# Sundry Print Report

Well Name: PAPAS FRITAS 27-22 FED Well Location: T23S / R29E / SEC 27 / County or Parish/State:

## **Notice of Intent**

Type of Action: Variance

#### **Section 2 - Blowout Preventer Testing Procedure**

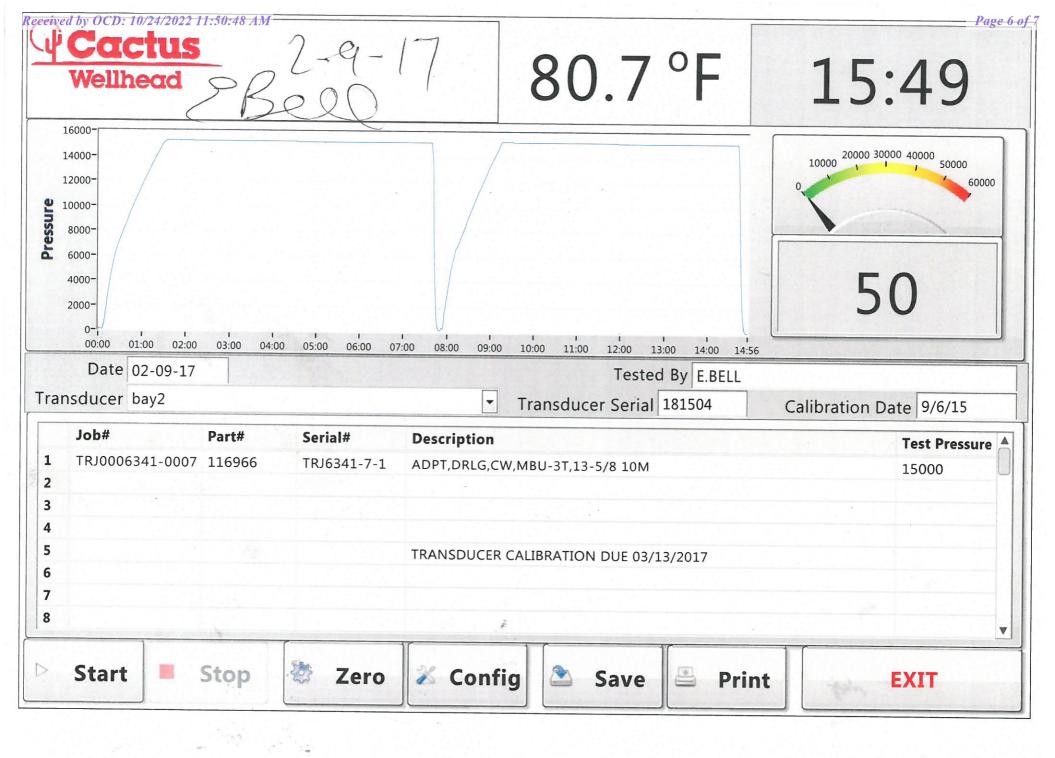
Devon Energy requests to only test BOP connection breaks after drilling out of surface casing and while skidding between wells which conforms to API Standard 53 and industry standards. This test will include the Top Pipe Rams, HCR, Kill Line Check Valve, QDC (quick disconnect to wellhead) and Shell of the 10M BOPE to 5M for 10 minutes. If a break to the flex hose that runs to the choke manifold is required due to repositioning from a skid, the HCR will remain open during the shell test to include that additional break. The variance only pertains to intermediate hole-sections and no deeper than the Bone Springs Formation where 5M BOP tests are required. The initial BOP test will follow OOGO2.III.A.2.i, and subsequent tests following a skid will only test connections that are broken. The annular preventer will be tested to 100% working pressure. This variance will meet or exceed OOGO2.III.A.2.i per the following: Devon Energy will perform a full BOP test per OOGO2.III.A.2.i before drilling out of the intermediate casing string(s) and starting the production hole, before starting any hole section that requires a 10M test, before the expiration of the allotted 14-days for 5M intermediate batch drilling or when the drilling rig is fully mobilized to a new well pad, whichever is sooner. We will utilize a 200' TVD tolerance between intermediate shoes as the cutoff for a full BOP test. The BLM will be contacted 4hrs prior to a BOPE test. The BLM will be notified if and when a well control event is encountered. Break test will be a 14 day interval and not a 30 day full BOPE test interval. If in the event break testing is not utilized, then a full BOPE test would be conducted.

- 1. Well Control Response:
- 1. Primary barrier remains fluid
- 2. In the event of an influx due to being underbalanced and after a realized gain or flow, the order of closing BOPE is as follows:
  - a) Annular first
  - b) If annular were to not hold, Upper pipe rams second (which were tested on the skid BOP test)
  - c) If the Upper Pipe Rams were to not hold, Lower Pipe Rams would be third

**Disposition:** Approved Disposition Date: 10/24/2022
